UNITED STATES PATENT AND TRADEMARK OFFICE

APPLICATION NO.	FILING DATE	FIRST NAMED INVENTOR	ATTORNEY DOCKET NO.	CONFIRMATION NO.
10/807,040	03/23/2004	Takashi Akita	04995/140001	2727

Office Action Summary

DETAILED ACTION

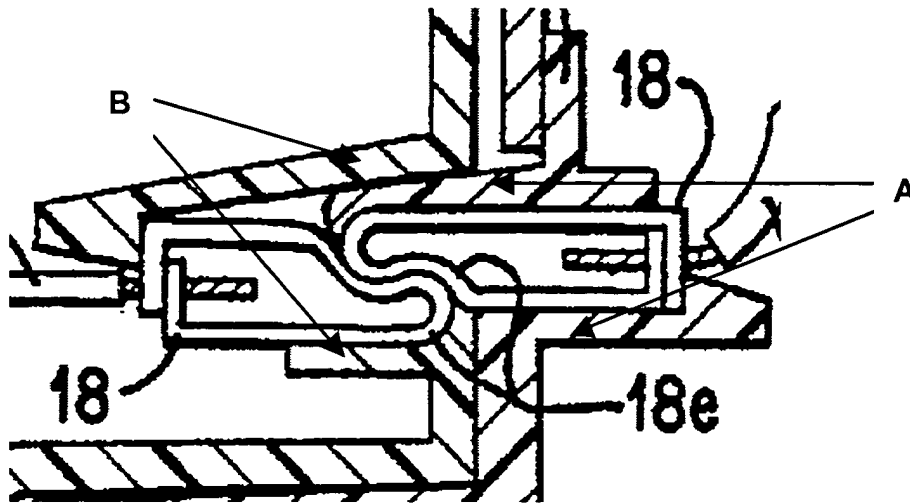
As to claim 1, Ponticelli et al. disclose an attachment structure of a rear panel to a tuner, in which a rear panel **12** is attached and fixed onto a front surface of a tuner (element **27**), the tuner having two connector connection parts **A** (Figure 6 reprinted below with annotations) protruding in front and a small protrusion **22** with a tapped hole for panel attachment provided in a middle position between the connector connection parts, the attachment structure comprising:

the rear panel having two holes for inserting the connector connection parts in portions corresponding to the two connector connection parts of the tuner and a small cylindrical part **14** that is formed in a portion corresponding to the small protrusion with the tapped hole of the tuner; and

a male screw **17**;

wherein the two connector connection parts of the tuner are inserted into the two holes of the rear panel, and a leading end of the small cylindrical part is brought into contact with a front surface of the small protrusion with the tapped hole of the tuner, and under this state, the male screw is inserted into the small cylindrical part from the front surface side of the rear panel and further a leading end of the male screw is screwed into the tapped hole of the small protrusion with the tapped hole of the tuner, whereby the rear panel is attached and fixed onto the front surface of the tuner (Figures 1 and 6).

As to claim 3, Ponticelli et al. disclose an attachment structure wherein the small cylindrical part **22** of the rear panel **27** is formed, and a peripheral projection part **B** that comes into contact with the front surface of the tuner **12** is formed in a portion of each of the two holes (Figure 6).

As to claim 4, Ponticelli et al. disclose an attachment structure wherein the small cylindrical part **14** of the rear panel **12** is formed;

in a portion of each of the two holes, a part **B** having plural cuts in circular direction of a hole edge is formed;

the cuts are bent toward the front side of the tuner **27** thereby to form a peripheral projection part **B**; and

a leading end of the peripheral projection part comes into contact with the front surface of the tuner (Figure 6).
